PRODUCT CHANGE NOTICE

PCN#23-084**NOTIFICATION DATE: December 12, 2023****MODELS AFFECTED**Please see 2nd and 3rd pages for list of models**EXTENT OF CHANGE:**

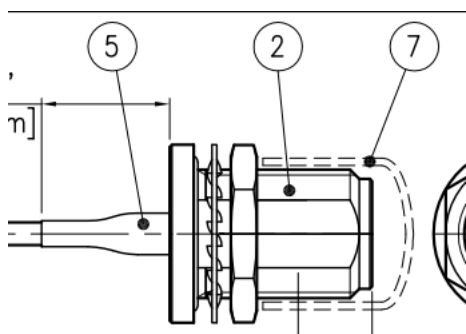
Add 'boot' to cable end with the N-type connector (item 5 below)

**EFFECT OF CHANGE:**Change to device, FORM (Appearance) and FUNCTION (Performance) improved strain relief.
No Change to FIT (Dimension)**REASON FOR CHANGE:**

Provide enhanced support for heavy connector on thin cable assembly
